Subject: Revision 4 to the Seabrook Plan for Massachusetts Communities

Revision 4 of the Seabrook Plan for Massachusetts Communities (SPMC) and its implementing procedures are submitted as Enclosure 1 pursuant to the requirements of 10CFR50.4(b)(5).

SEABROOK PLAN FOR MASSACHUSETTS COMMUNITIES
REVISION 4

CHANGE SUMMARY (ROADMAP)

FIGURE 5.2-14
NEWBURYPORT VANS STAGING AREA FACILITY LAYOUT

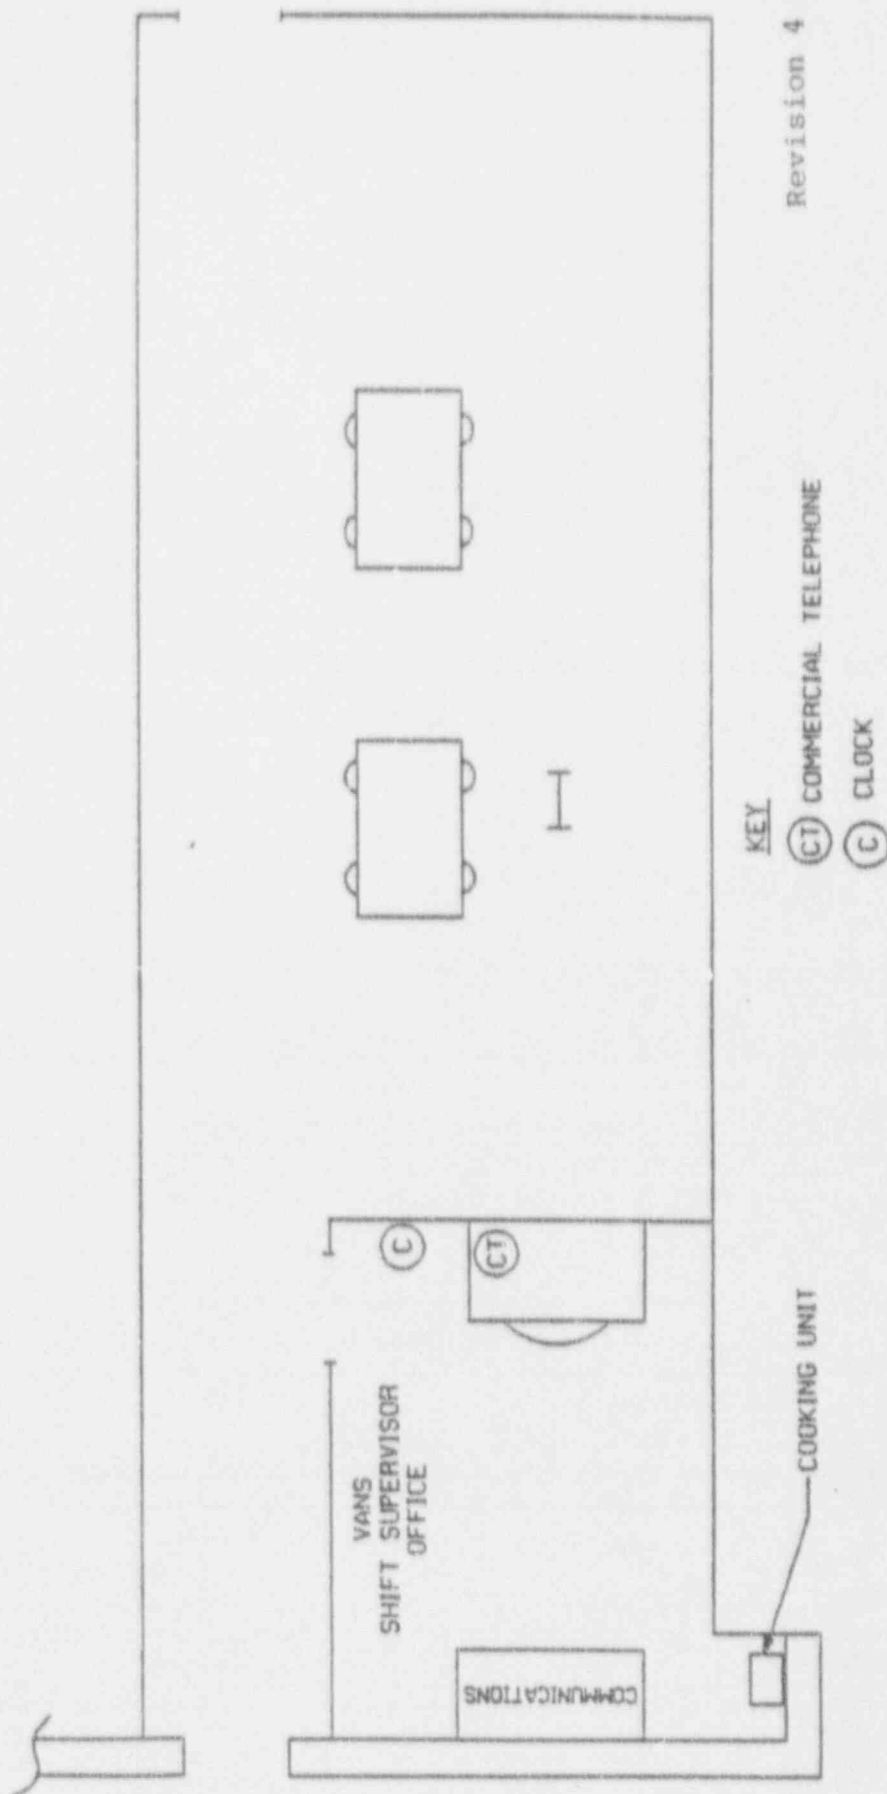
AFFECTED SECTION	ISSUE	CORRECTIVE ACTION	SOURCE OF COMMENT
Plan, Sec. 3.2.5 and 5.2.5 and IPs 2.13 and 2.16	VANS has been replaced in five of six MA communities by pole-mounted sirens. VANS continues as the primary public alert system in West Newbury.	Revised Plan Sections 3.2.5 and 5.2.5 and associated procedures in IPs 2.13 and 2.16 to show change from VANS to pole mounted sirens in five communities	Mass transition project
App. G, p. G-3 and Att. 14	EOC Contact Emergency Response Manual lacks instructions for Unusual Event immediately terminated and for sending event termination codes.	Revised App. G to direct EOC Contacts to obtain instructions from on-duty Offsite Response Director for making notifications for Unusual Event immediately terminated; revised Att. 14 to add instructions for making notifications of termination of an Unusual Event.	7/3/92 Unusual Event declaration
IP 2.12, Att. 7	The pre-scripted news releases refer to New Hampshire Yankee	Changed pre-scripted news releases to refer to North Atlantic	Managing agent change

be accomplished in the event of an emergency. Figures 5.2-14 and 5.2-15 detail the individual VANS Staging Area and Backup VANS Staging Area.
